# UNITED STATES PATENT AND TRADEMARK OFFICE

APPLICATION NO.	FILING DATE	FIRST NAMED INVENTOR	ATTORNEY DOCKET NO.	CONFIRMATION NO.
10/623,781	07/21/2003	Jonathan E. Ricketts	17313	6104

## Office Action Summary

## DETAILED ACTION

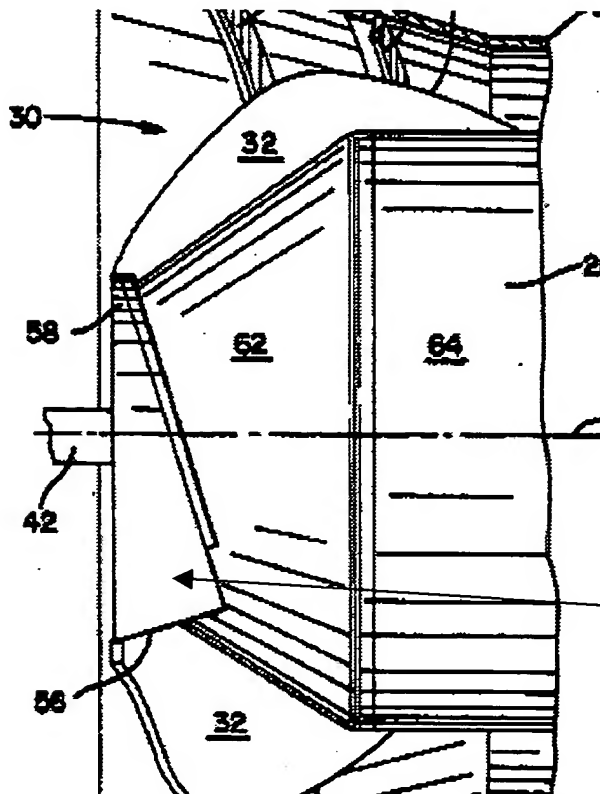
2. Claims 1-8 are rejected under 35 U.S.C. 102(b) as being anticipated by Tanis (5387153).

Tanis discloses:

An extension for a helical flight extending around a front inlet end of a rotor of a threshing system of an agricultural combine, the rotor being rotatable in a predetermined rotational direction about a rotational axis therethrough and the flight including a leading edge extending radially outwardly from the front inlet end of the rotor and a rearwardly facing helical crop flow surface extending rearwardly from the leading edge at a first predetermined angle of attack relative to a plane perpendicular to the rotational axis, for conveying crop materials from adjacent the inlet end of the rotor radially outwardly and rearwardly when the rotor is rotated, the extension comprising:

an elongate blade shape member removably mountable in radially outwardly extending relation along the radially outwardly extending leading edge of the flight, the blade shape member being disposed so as to be located forwardly of the leading edge of the flight with respect to the predetermined rotational direction along at least a

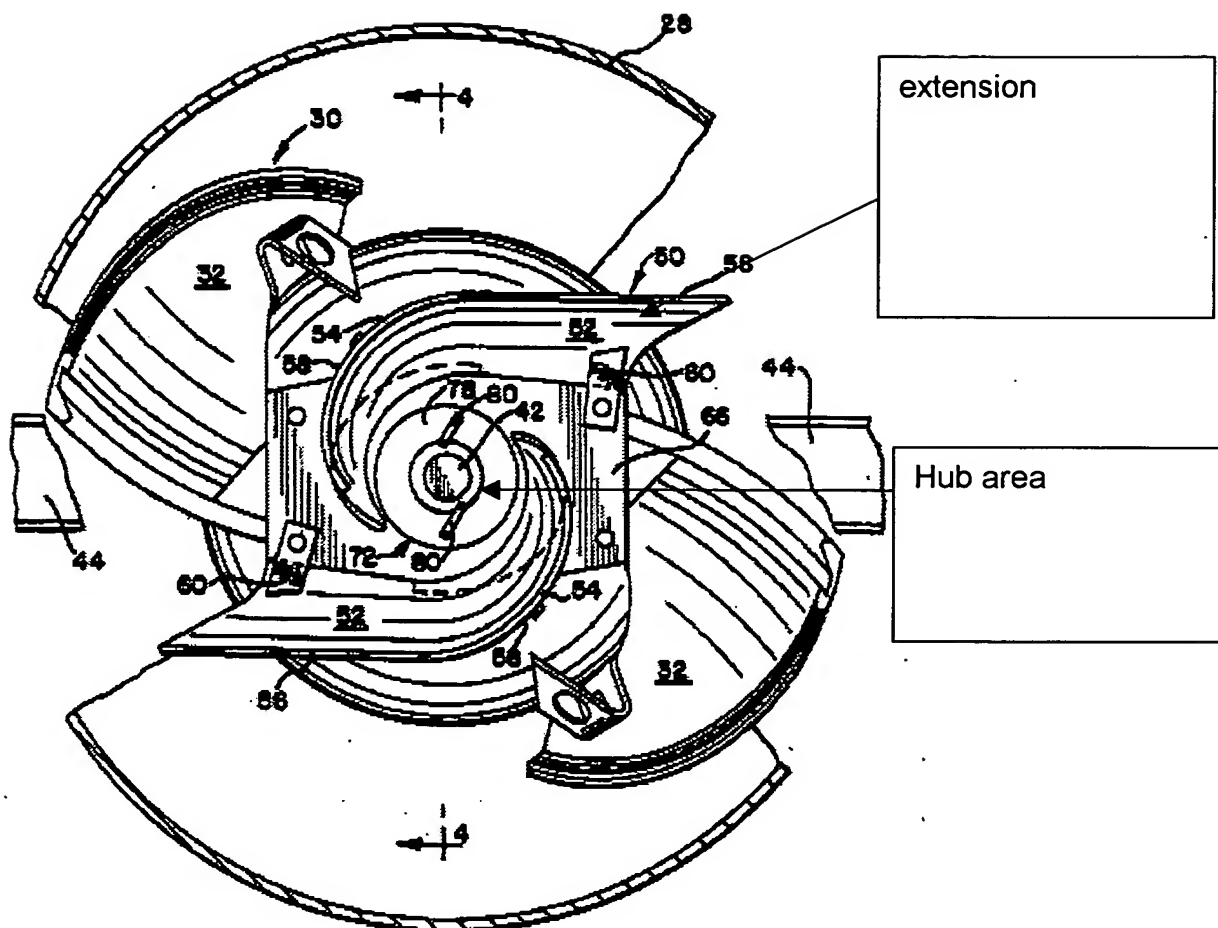
substantial portion of a radial extent thereof when mounted thereon the blade shape member having a leading edge having a curved swept back shape, and a rearwardly facing crop flow surface oriented at a second predetermined angle of attack less than the first predetermined angle of attack, such that when the rotor is rotated in the predetermined direction the member will accelerate crop material that comes into contact with the leading edge thereof radially outwardly and rearwardly onto the flight and generate a rearwardly directed air flow (as shown in fig 3, ref 56 shows a blade shape extension to a flight at the front inlet section radially outwardly & forwardly of a leading edge of the flights as claimed)

an elongate blade shape member  
removably mountable in radially  
outwardly extending relation along the  
radially outwardly extending leading  
edge of the flight
